Roads and Assets Referral Response

Application Number:	DA2021/2639
Date:	24/06/2022
To:	Olivia Ramage
Land to be developed (Address):	Lot 52 DP 7593 , 25 Alleyne Avenue NORTH NARRABEEN NSW 2101

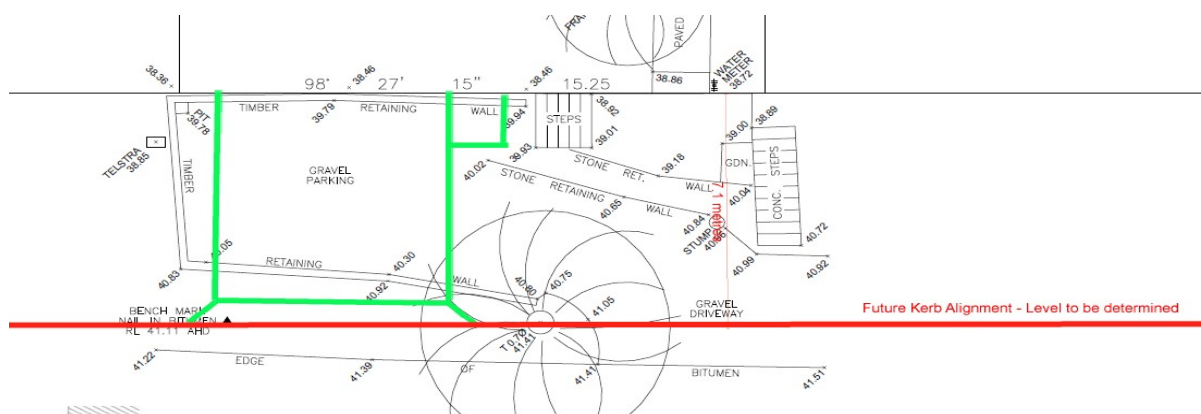
The design plan dated 22/5/2022 also does not comply with low level skew profile levels and the use of such a profile on the current alignment of the unauthorised parking area is not supported. A driveway crossing perpendicular to the carriageway is required in compliance with Council's standards.

The existing road surface levels may be lower than that required in the future. If road levels are raised, to be consistent with the existing longitudinal grade of the road, the driveway (which are at maximum grades) and car port levels will be impacted.

The construction of kerb and gutter across the frontage to connect to the existing k&g would be supported and would aid stormwater drainage.

Driveway access from the carriageway should be at 90 degrees to the carriageway to improve safe access, although noting this may result in lifting the car port floor level.
